**SUBJECT: ADDENDUM NO.1 / STATE ROUTE 32 WIDENING (PHASE 1) –  
PROJECT No. 15010 – FROM EAST OF PARK AND RIDE LOT TO EL MONTE AVE**

**ADDENDUM NO. 1**

The contract plans and specifications for the above noted project are hereby modified as follows:

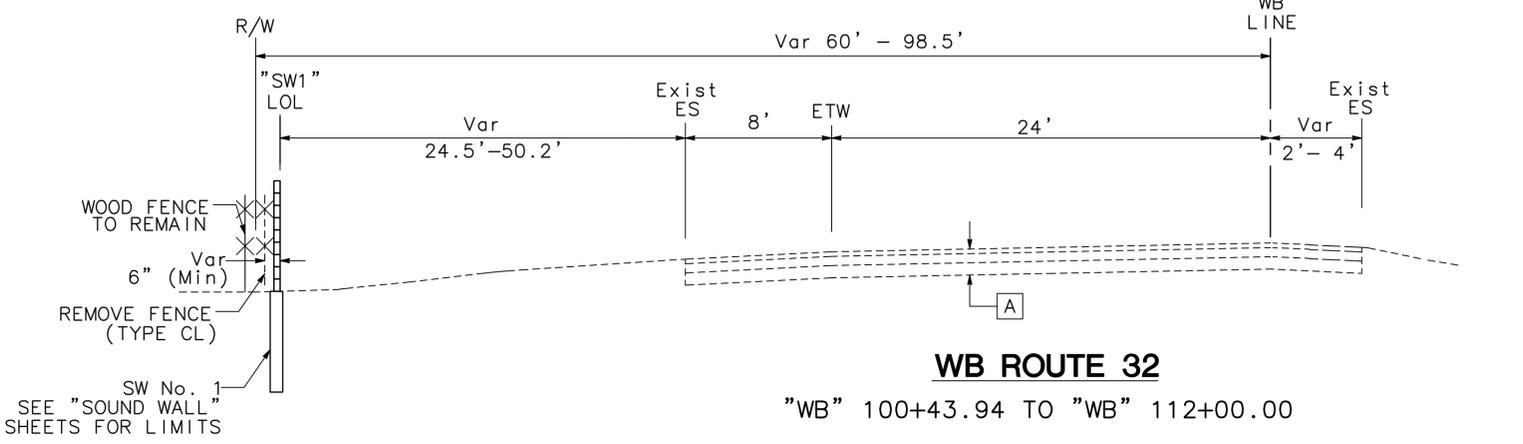
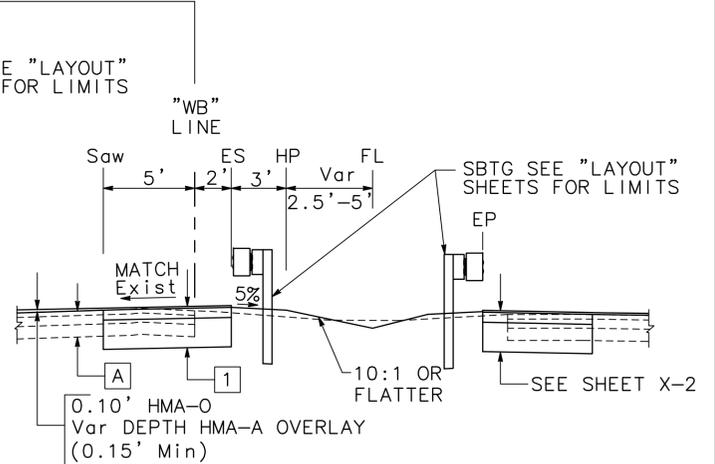
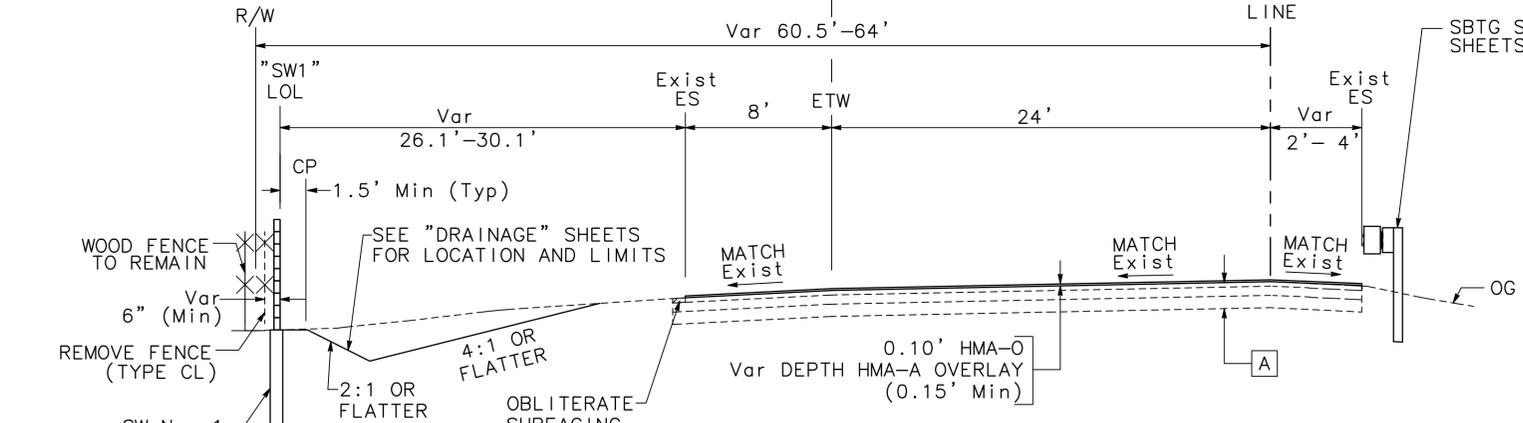
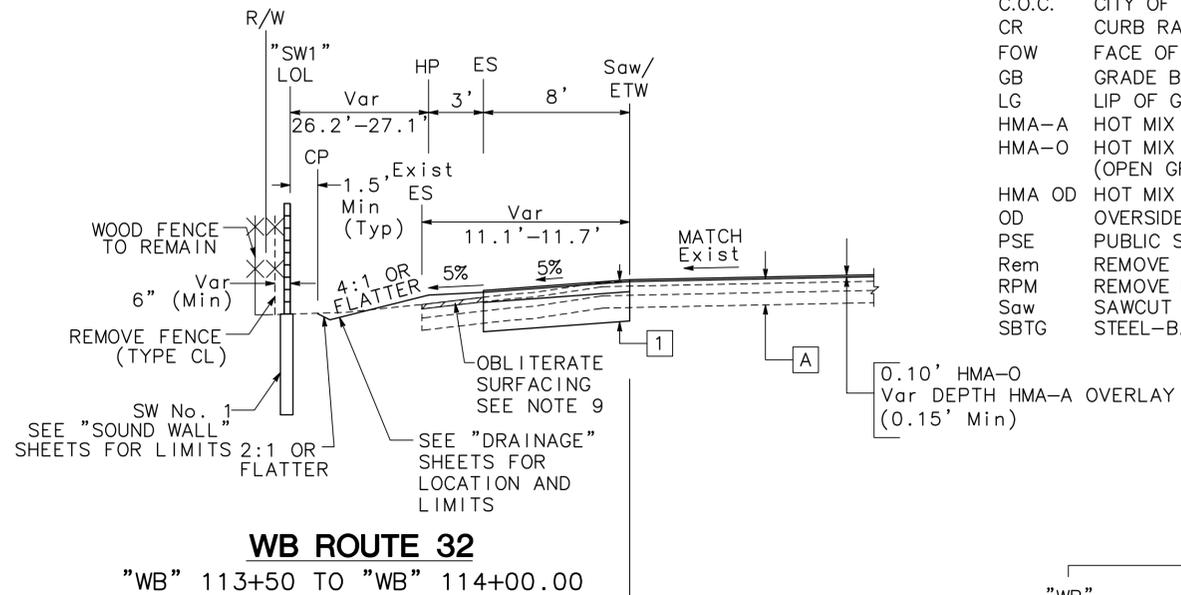
ITEM	PAGE/SHEET	DESCRIPTION OF CHANGE/INSTRUCTIONS
1	Plan Sheet X-1	Pavement Structural Section 5 has been removed.  Replace plan sheet X-1 with Revised X-1 dated 1-11-2012
2	Plan Sheet C-3	Minor Concrete (Textured Paving) Detail has been revised.  Replace plan sheet C-3 with revised C-3 dated 1-11-2012.
3	Plan Sheets U-2, U-3, Q-3	Irrigation crossover locations and sizes have been updated.  Replace plan sheets U-2, U-3, and Q-3 with revised U-2, U-3, and Q-3 dated 1-11-2012.
4	Plan Sheet SC-2	Construction Activities (Stage 3), Note 10 has been modified.  Replace plan sheet SC-2 with revised SC-2 dated 1-11-2012.
5	Plan Sheets LS-1.7, LS-1.10	Plant Reference Symbols G-1 have been replaced with S-18.  Replace plan sheets LS-1.7 and LS-1.10 with revised sheets LS-1.7 and LS-1.10 dated 1-11-2012.
6	Plan Sheets LS-2.0 through LS-2.8	Irrigation Plans have been revised.  Replace plan sheets LS-2.0 through LS-2.8 with revised LS-2.0 through LS-2.8 dated 1-11-2012.
